Record SPLN24-00004:

Special Exception Site Plan

Project Name: 3130 Langston Boulevard

DRAWN BY:	
DESIGNED BY:	
DATE ISSUED:	08/09/2024
DWG. SCALE:	1" = 25'
VIKA NO.:	VV8574A
SHEET NO.:	C-08

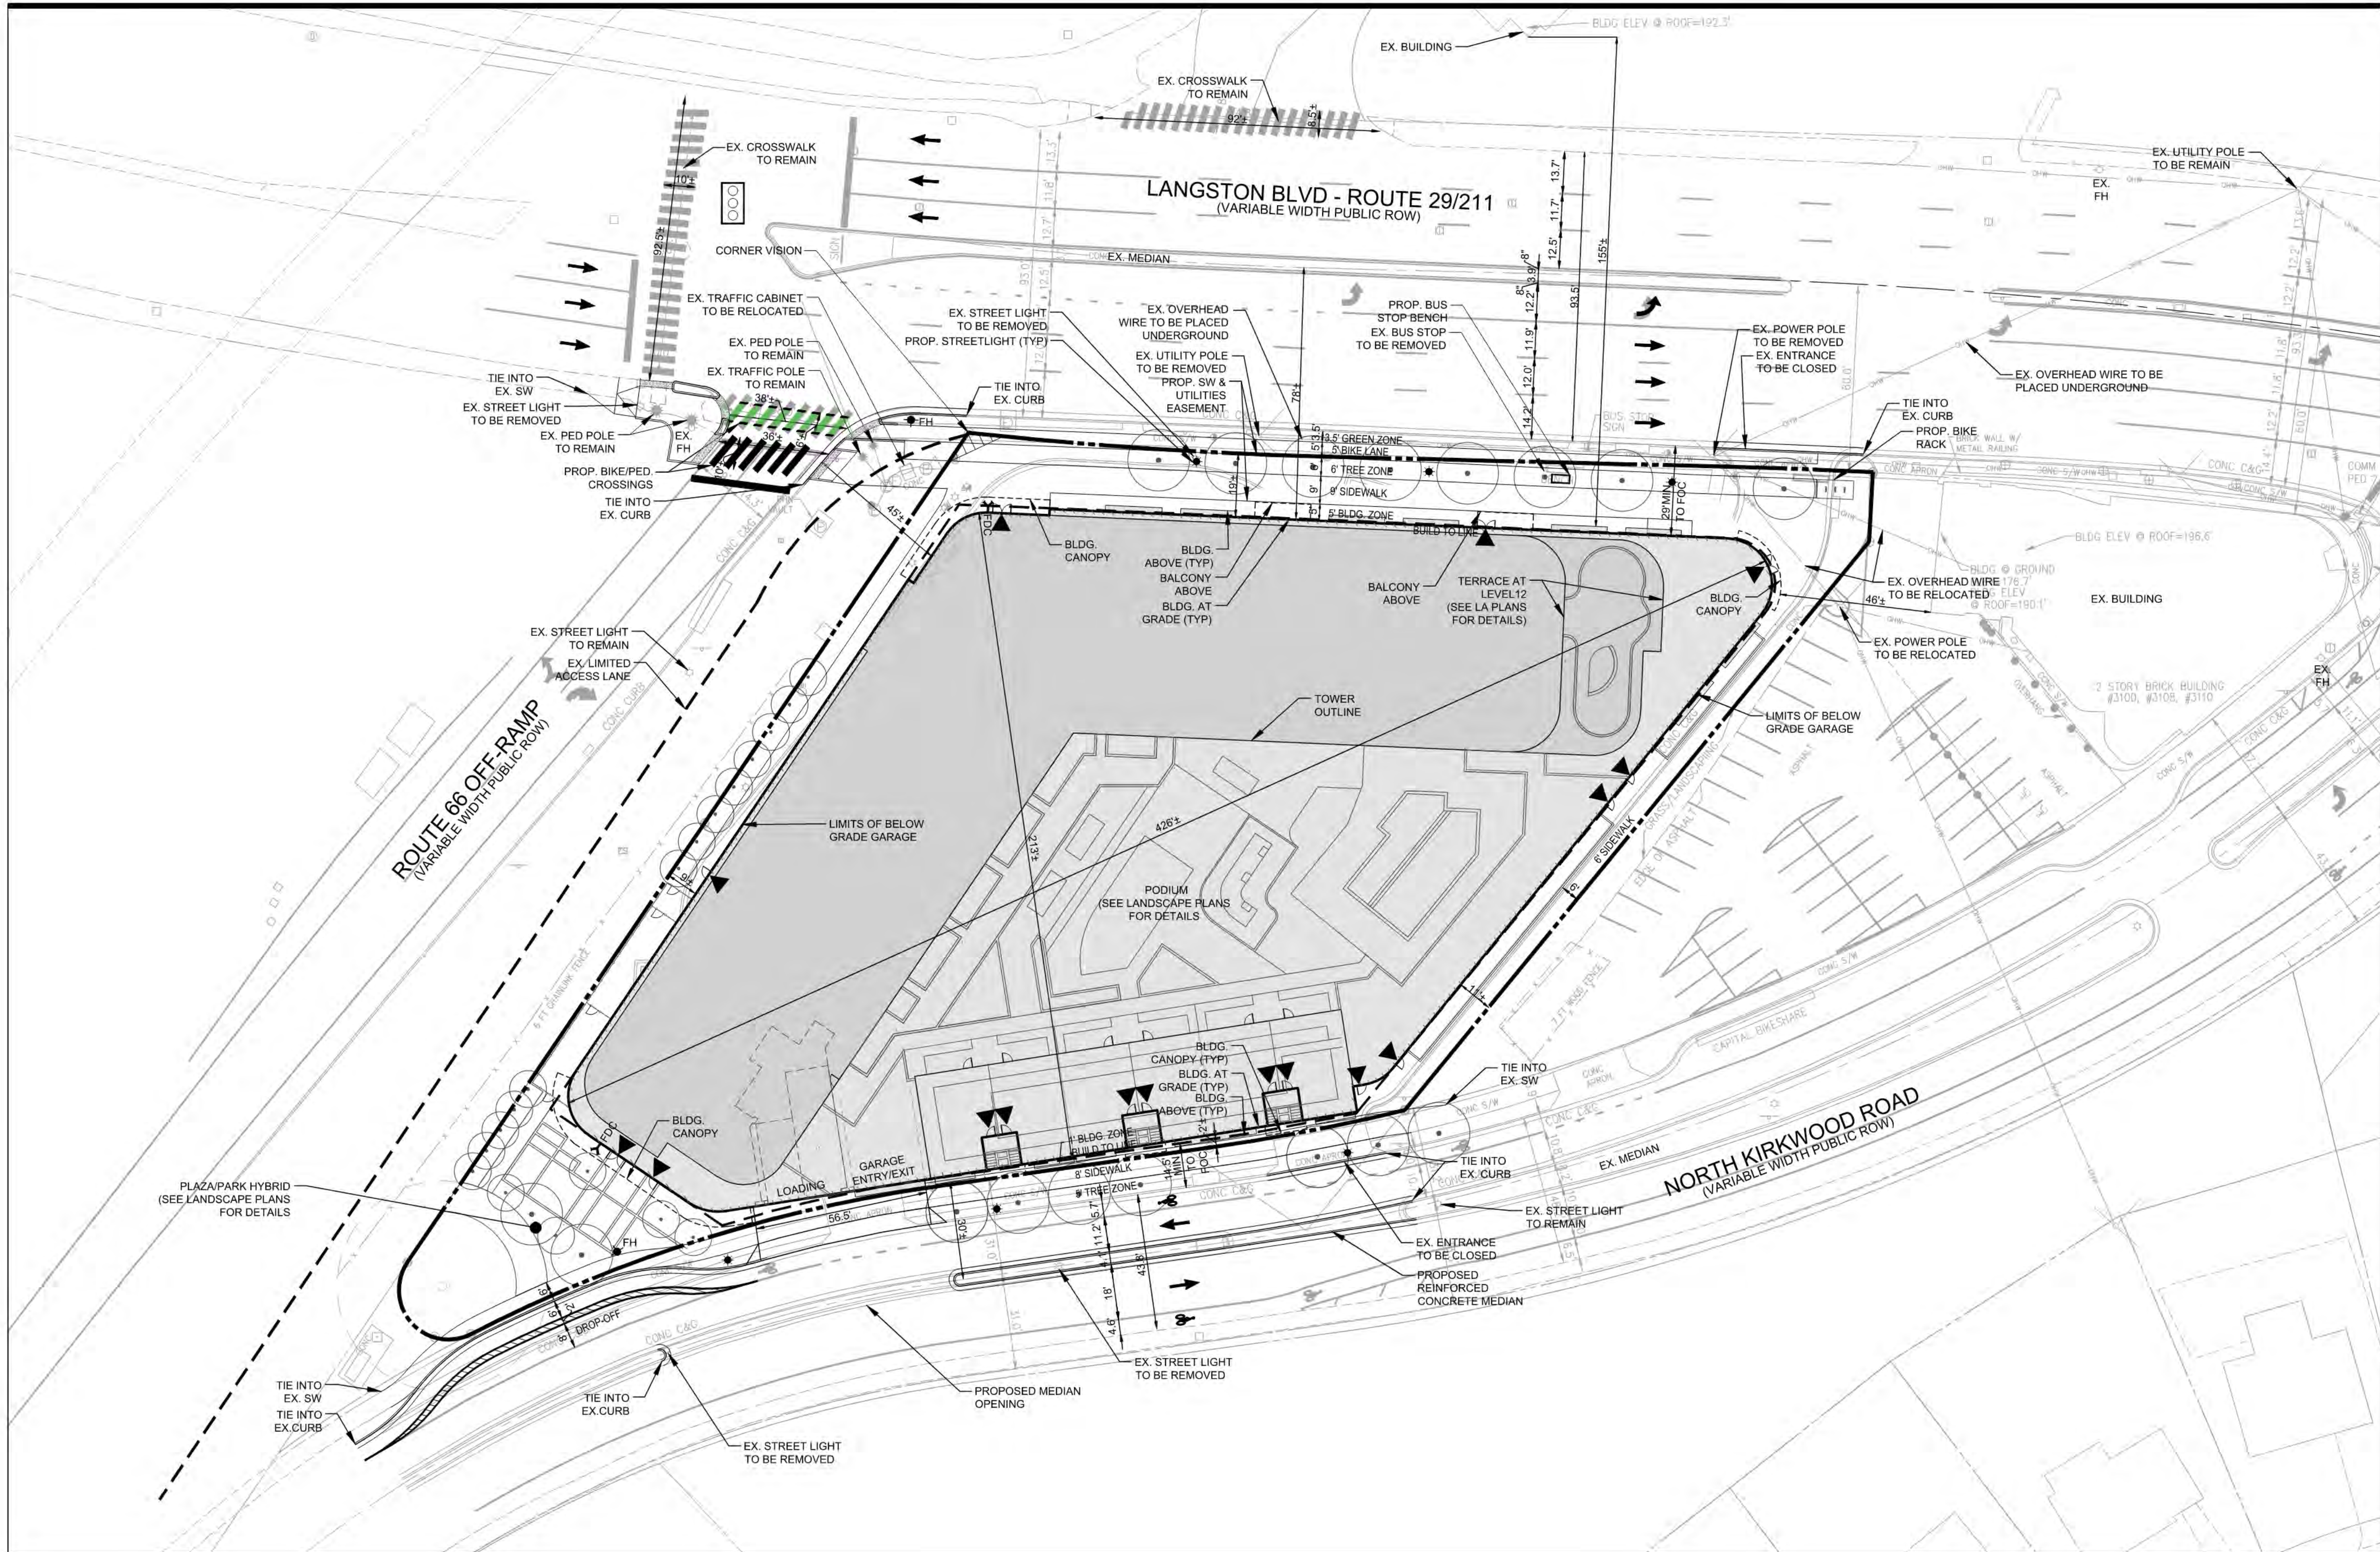
our records.	
DES DSB Planning	DES-PLN-7		JSKIM	All proposed transformers to be underground; if above ground, must be adequately screened from public ROW	An underground transformer vault will be located on Langston Blvd. See sheet C-08.
DES DSB Planning	DES-PLN-8		JSKIM	Standard site plan condition requires all existing utility poles around the site vicinity to be undergrounded	Understood. See sheet C-08 for utility pole and overhead lines that are to be removed or undergrounded.
DES DSB Planning	DES-PLN-9		JSKIM	Please show RPA information as applicable. If there is an RPA on site, reach out to Jane Kim to schedule a meeting with applicable DES staff.	RPA information is shown on sheet C-01 and C-08. Additionally, we have met with Arlington County staff to clarify our request for redevelopment within the RPA. We are preparing a Site-Specific RPA plan to refine/confirm the exact location of the RPA and will work with DES staff to work through the CBORC to gain approval of our proposed project.

DES Transportation Planning	DES-TP-1	L-01 LA CONCEPT	ABULLOCK 1	For the proposed median opening on Kirkwood Rd, it appears this is designed to only allow NB left turns from Kirkwood into the driveway, and not left turns out of the driveway and onto Kirkwood. Is the driveway proposed as right-out only? Please confirm.	The median opening has been designed to accommodate both left & right turns out of the garage. See sheet C-08.

DES Transportation Planning	DES-TP-4	L-01 LA CONCEPT	ABULLOCK 1	Is any use planned in the 5' building zone along Langston Blvd? Or is this intended to be solely shy space for door swing, etc.?	The 5' building zone will include planter beds, door swings and balcony projections.
DES Transportation Planning	DES-TP-5	L-01 LA CONCEPT	KCALKINS	Where will PUDO be accommodated on site? There are no apparent curbside spaces available for this. Consider integrating this on the Kirkwood frontage.	Two to Three PUDO spaces will be provided on Kirkwood near the secondary lobby. See sheet C-08.

DRAWN BY:	
DESIGNED BY:	
DATE ISSUED:	08/09/2024
DWG. SCALE:	1" = 25'
VIKA NO.:	VV8574A
SHEET NO.:	C-11

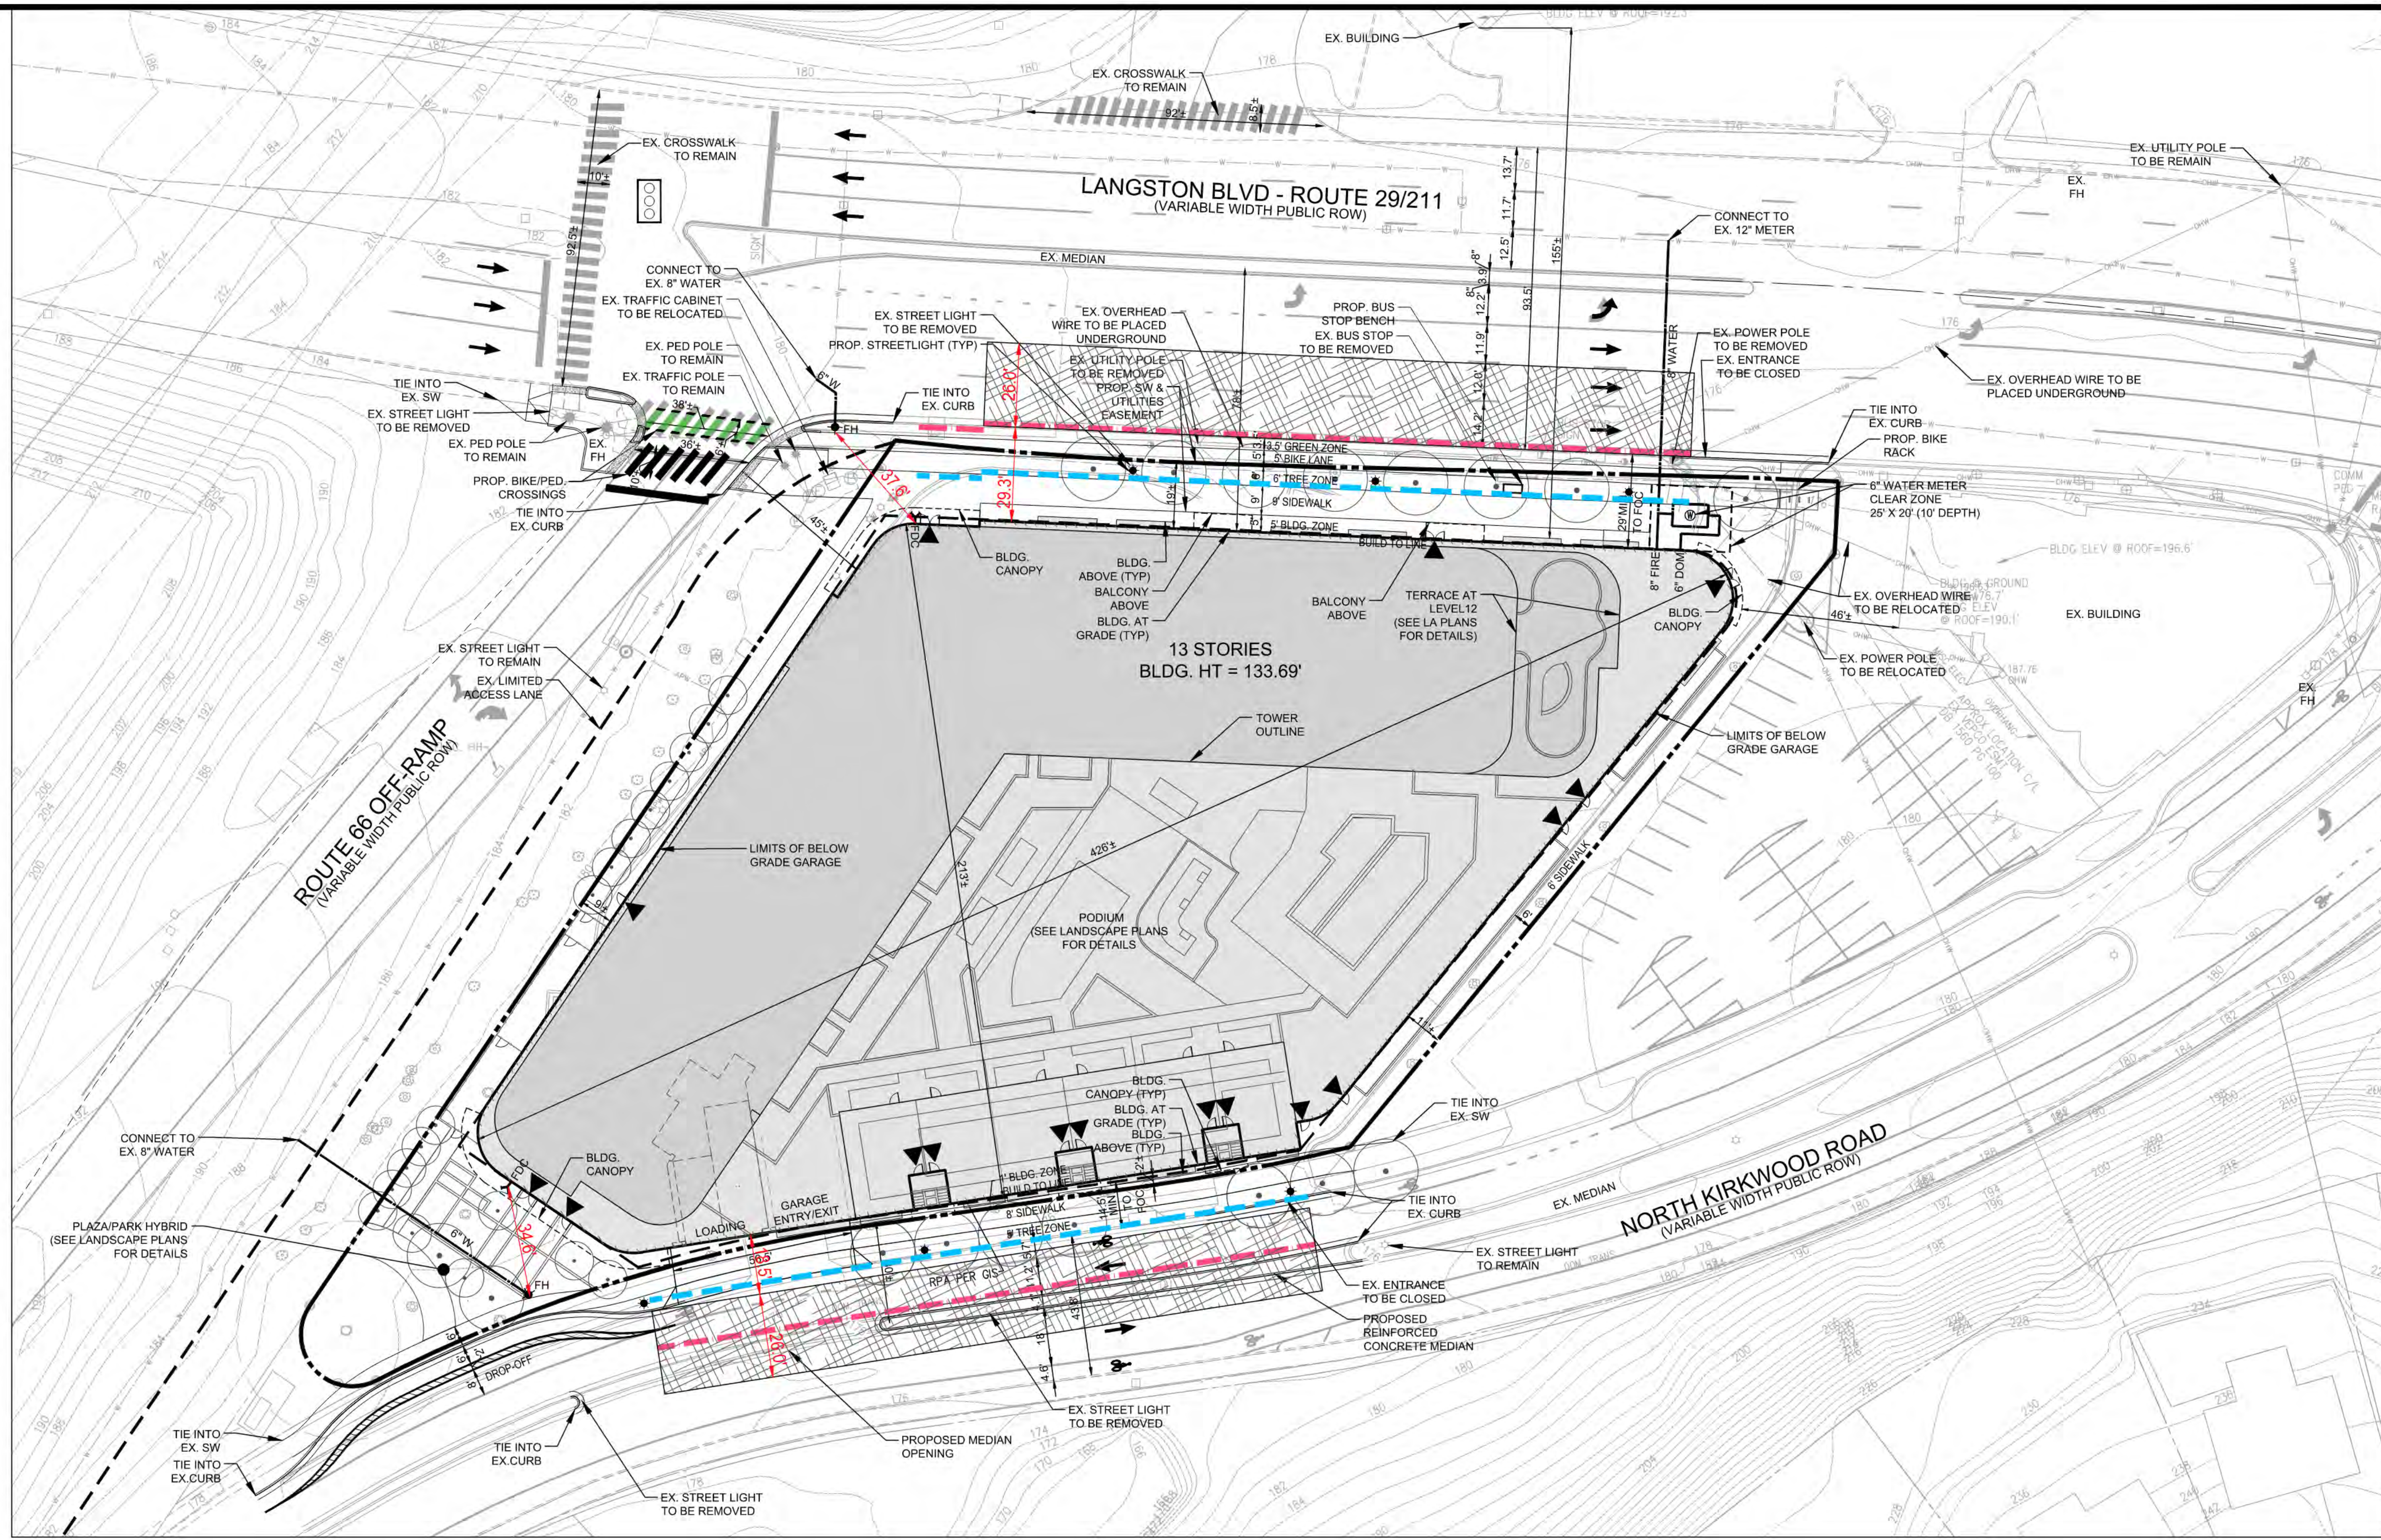
Fire Prevention	FP-1	A02	GKARL	Indicate which side will be used to meet aerial access requirements.	Langston and Kirkwood will be utilized to meet aerial access requirements. See Sheet C-11.
Fire Prevention	FP-2	A02	GKARL	Show proposed location of fire department connections and hydrants.	Proposed fire hydrants and fire department connections are shown. See Sheet C-08 & C-11.
